Project
34 Hillside Gardens Northwood
HA6 1RI

Drawing Title
Proposed Rear and Side East Elevations

Drawn MH	Date Jan 2025	Scale @ A3 1:100
Job No 024.004	Drawing No PL035	Revision B

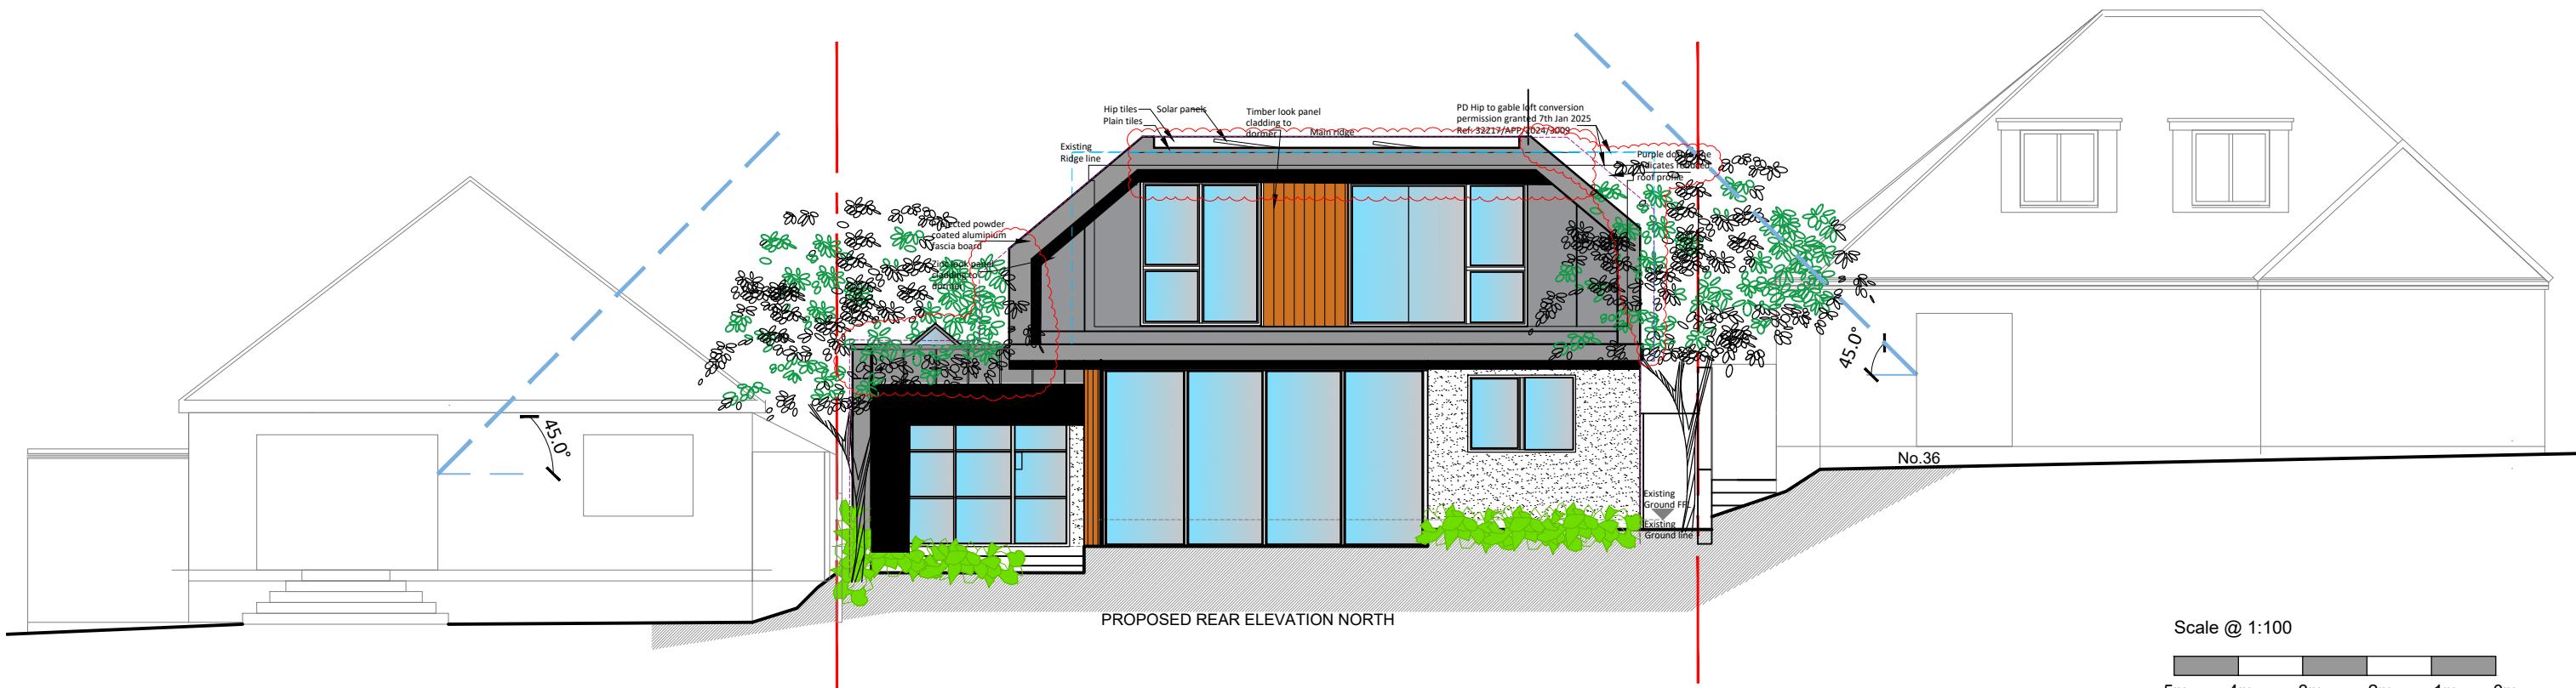
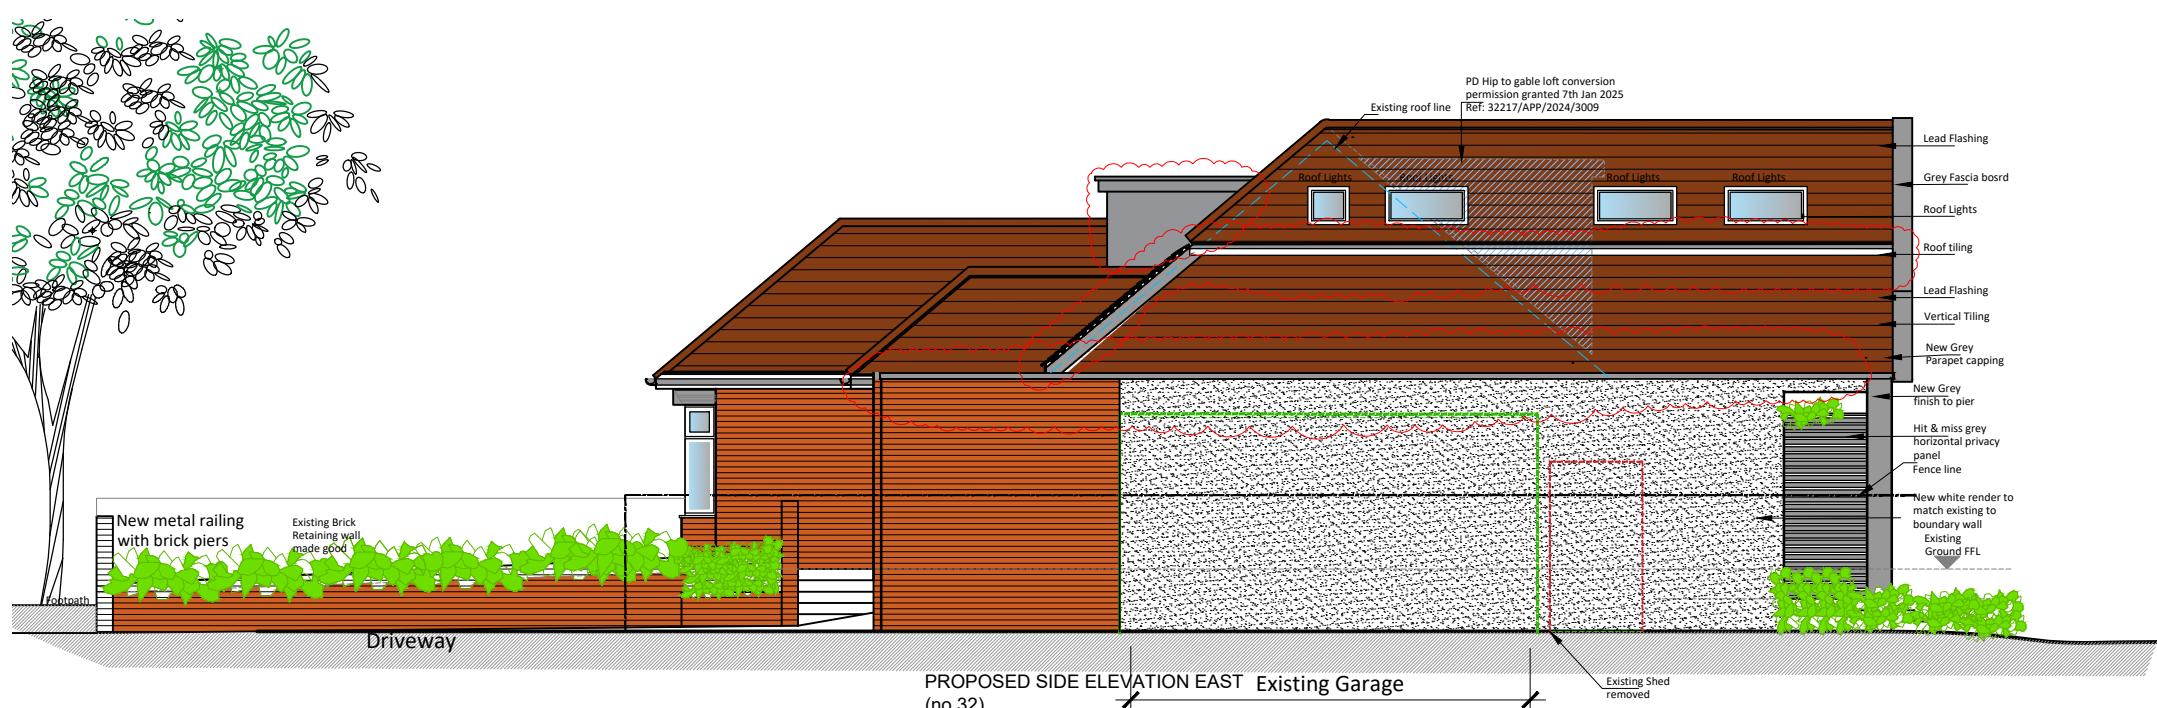
GENERAL NOTES			
Rev	Date	Description	By
A	14-02-2025	Issued for full planning	MH
B	28-04-2025	Rear and East side elevation revised to incorporate planning officers comments dated 22nd April 2025. Revisions clouded for clarity.	MH
